## Report #1:

## Report #2:

**Figure 9 – 8 h TO-11A DNP observations compared to Picarro G2307 observations at the SDK site from June through August 2022. Error bars represent the 10 % and 20 % uncertainty associated with the G2307 and TO-11A measurements.**

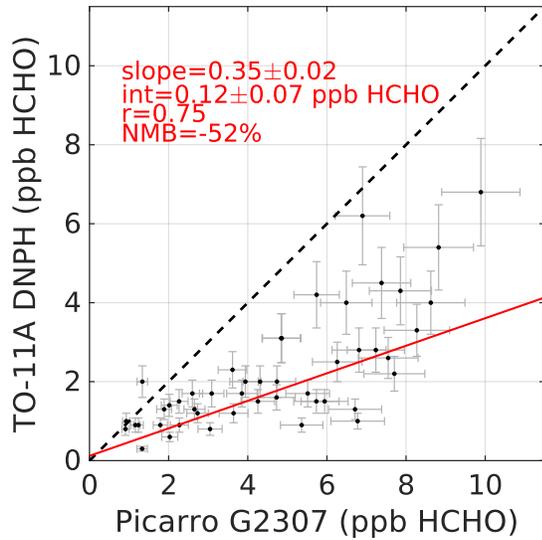
Figure 9 - The error bars on the TO-11A DNPH measurements seem way too small. You state earlier the uncertainty in the calibration standard is 15% (Line 367), so the total uncertainty in the measurement must be larger than this. As per the PAMS Technical Assistance Document, precision for collocated samples needs to be +/- 20%, so it's unlikely the uncertainty in the DNPH measurements will be below this. Double check the uncertainty in the DNPH measurements and correct the error bars accordingly.

We now ascribe an uncertainty of 20% to the DNPH measurements per section 13.4 of the TO-11A compendium. We have recalculated Fig. 9 accordingly and updates to the manuscript reflecting the new values can be found below:

Lines 369-371: “Method TO-11A requires that collocated DNPH-samples produce observations within 20 %, which is vindicated through EPA historical data (U.S. EPA, 1999). As such, an uncertainty of 20 % is assumed for TO-11A observations in this work.”

Lines 514-516: “Fig. 9 compares G2307 observations from June-Aug. 2022 with those from co-located TO-11A measurements. 1 min integrated G2307 concentrations are averaged to the 8 h TO-11A sampling window. We find moderate correlation ( $r = 0.75$ ) and a -52 % NMB of TO-11A observations relative to the G2307 (slope =  $0.35 \pm 0.02$ ).”

Lines 534-535: “Figure 9 – 8 h TO-11A DNPH observations compared to Picarro G2307 observations at the SDK site from June through August 2022. Error bars represent the 10 % and 20 % uncertainty associated with the G2307 and TO-11A measurements.”
